We are writing to formally object to the proposed development at **11 Glebe Road, RG2 7AG** (Planning Application No. PL/24/1083, PP-13330496), which involves the construction of eight one-bedroom flats and a new dwelling. The proposed development would invade our privacy as next door neighbours and stands in stark contrast to the established character of the road, which predominantly consists of family homes. The introduction of high-density, small-unit flats is inconsistent with the intended purpose and character of the area, and it would significantly alter the fabric of the neighbourhood.

# Expansion on Objections to the Proposed Development at 11 Glebe Road, RG2 7AG (Planning Application No. PL/24/1083, PP-13330496)

**Figure 1.** Visually depiction in broad lines the scale of objections to the proposed development.

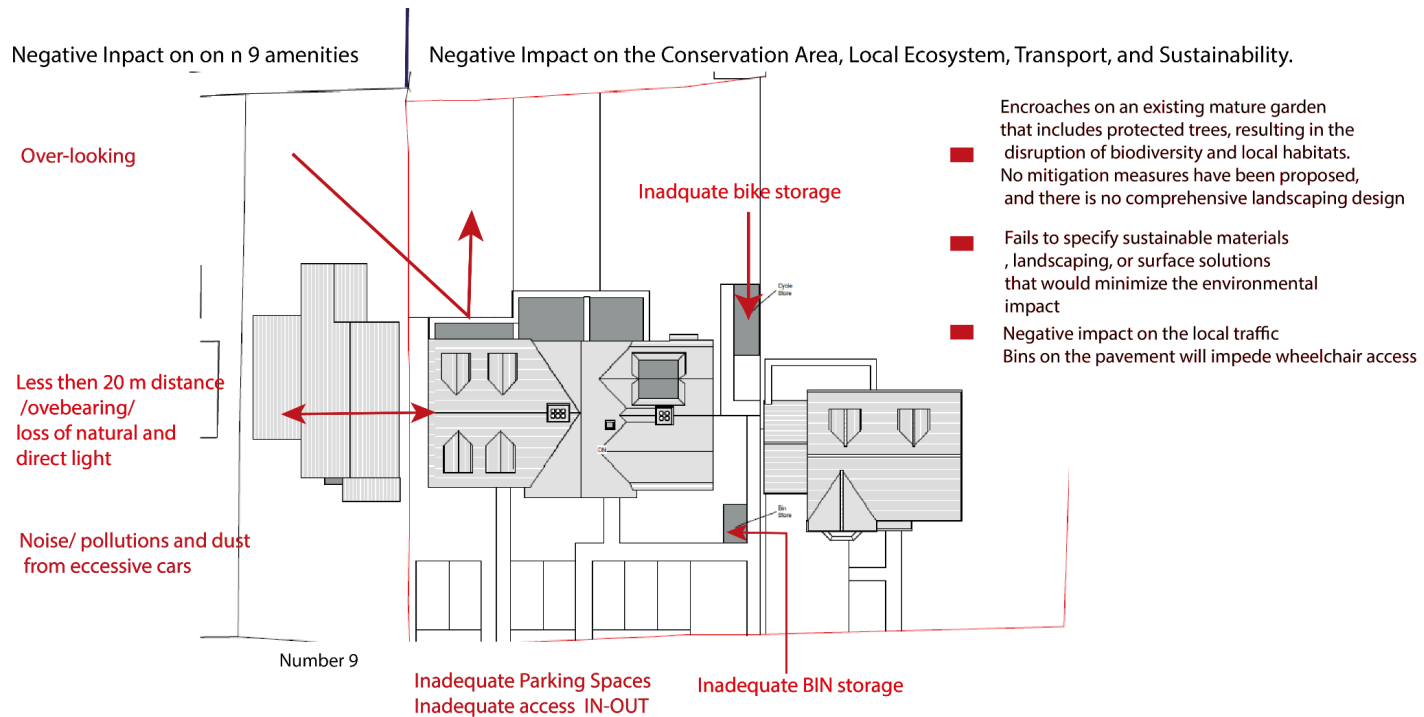
In this more extensive document, we elaborate on the rationale behind the six main objections we have expressed in our request for planning permission refusal. A visual summary of our main concerns is presented in Figure 1.

**The plan only provides 7 off-road** parking spaces for the converted block of flats and a separate parking area for the single dwelling (figure 1). The lack of one off-road parking space per unit is in contrast to national and local regulations which for our areas specify 1 off-road parking for 1-2 bedroom flats and 1.5 for 3+ bedroom houses. It also relies on the assumption that families in the two-bedroom flats will only have one car and will not need to park on the road. It also does not account for visitor parking which will have to make use of road parking. Additionally, the design does not consider that, to access the premises with such a large number of cars, two entrances—one for IN and one for OUT—should be considered. If this were taken into consideration, then the available spaces would reduce to only 5. No provision of disabled access is given.
